CALC	AERODYNAMICS	9Dec15	REVISED	DATE	TTQ 737-500 GO-AROUND ACCIDENT 17NOV13--TIME-ALIGNED FDR DATA EVENT VS. PRE-EVENT FLIGHT, ELEV X-PLOT(TKO)	PT211/VQ-BBN
CHECK				FIGURE 1		
APPD.				PAGE		
APPD.

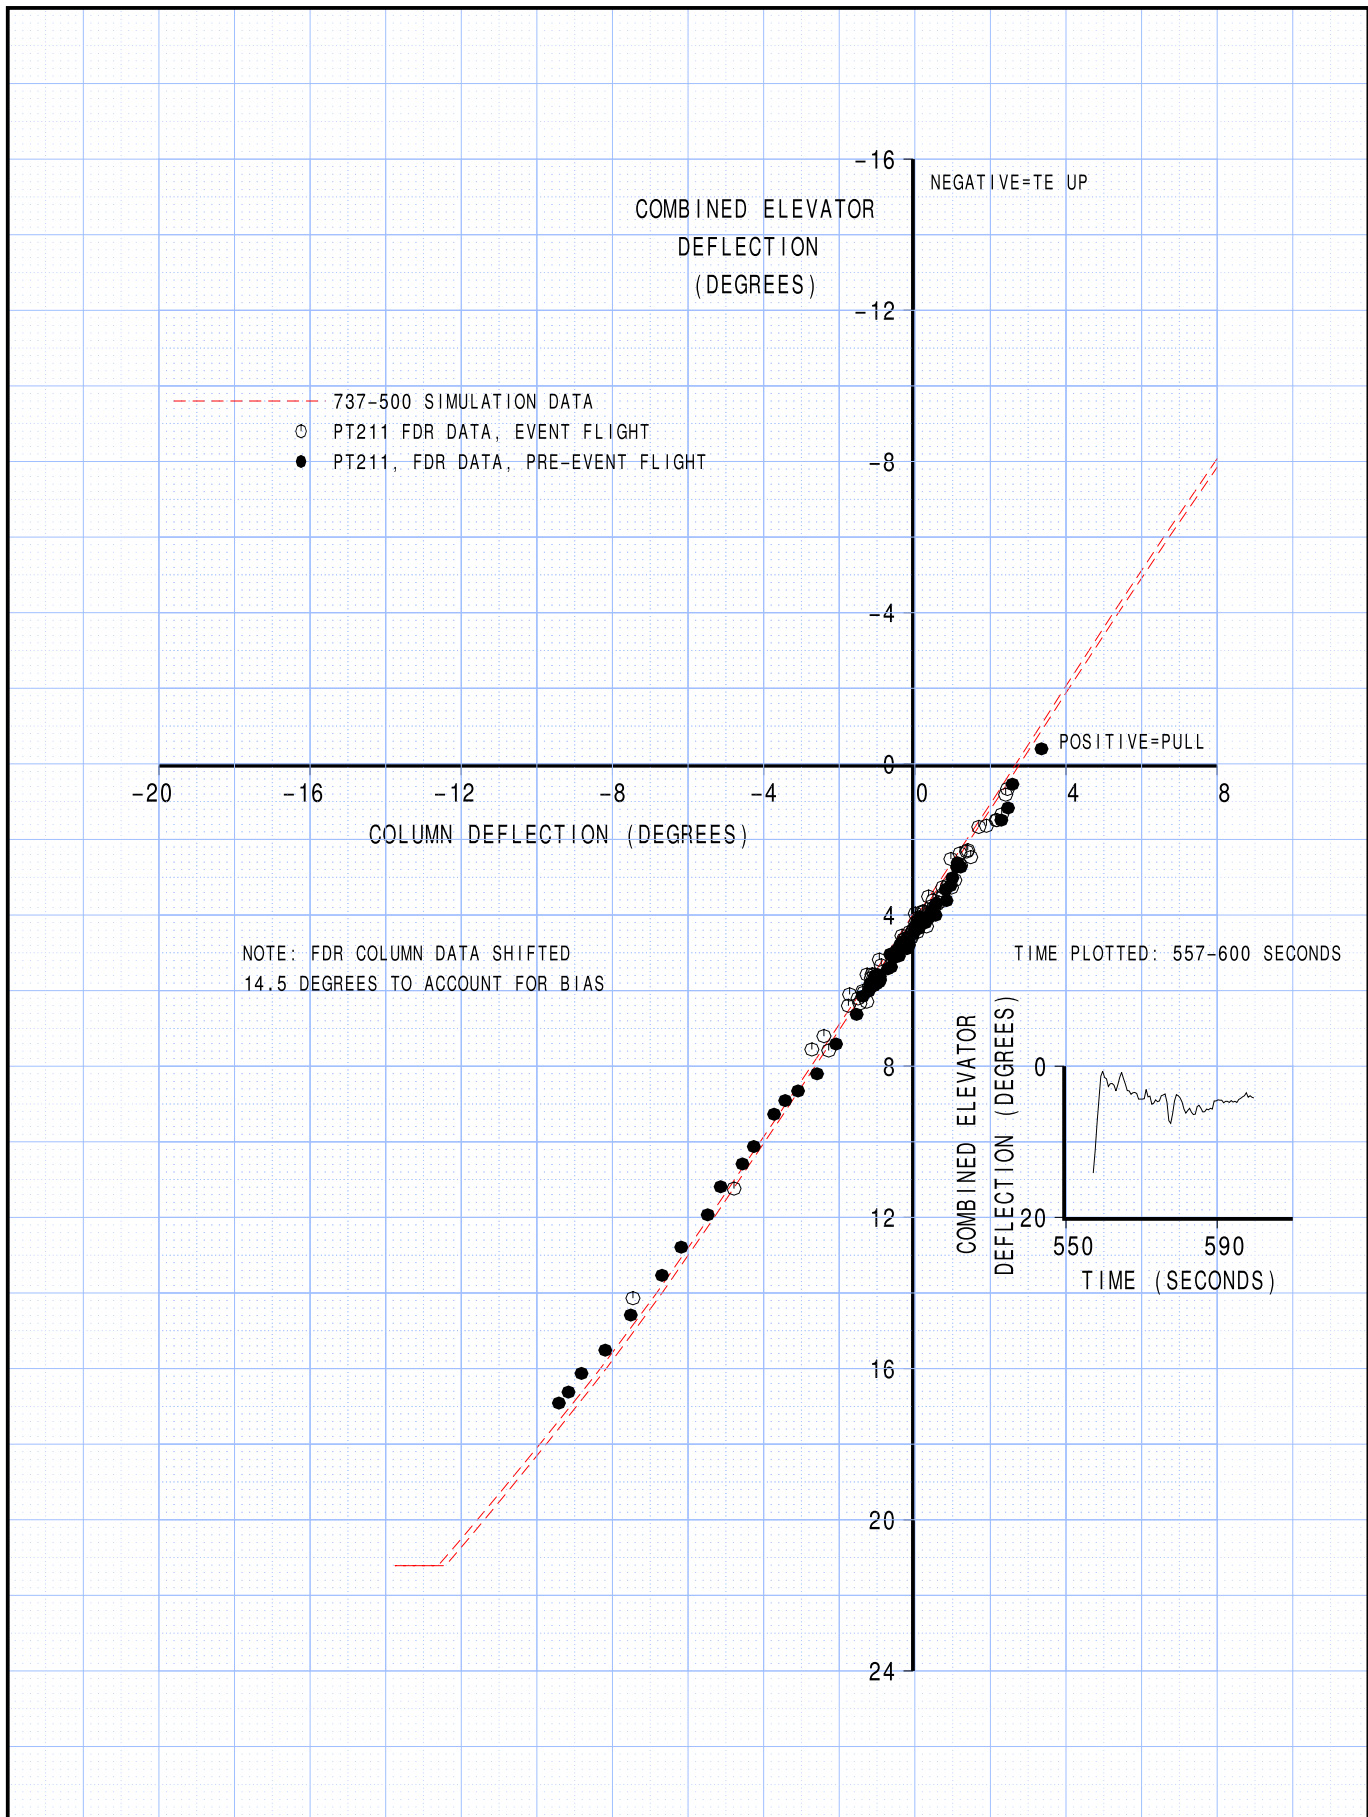
“In the Report the elevator/column relations during go around in FD mode in other flights are not present, the comparative analysis of these relations to the relation, shown during the accident flight, has not been conducted either.”

Response: The previous flight’s FDR data were provided for analysis. The analysis shows that no go-around was performed in the previous flight; however, other portions of the flight were reviewed and analyzed. The data show the elevator deflected linearly with column, as expected, for the takeoff (Figure 1) and landing (Figure 2) of the flight before the accident flight. Furthermore, the elevators deflected as expected during takeoff of the accident flight (Figure 1).
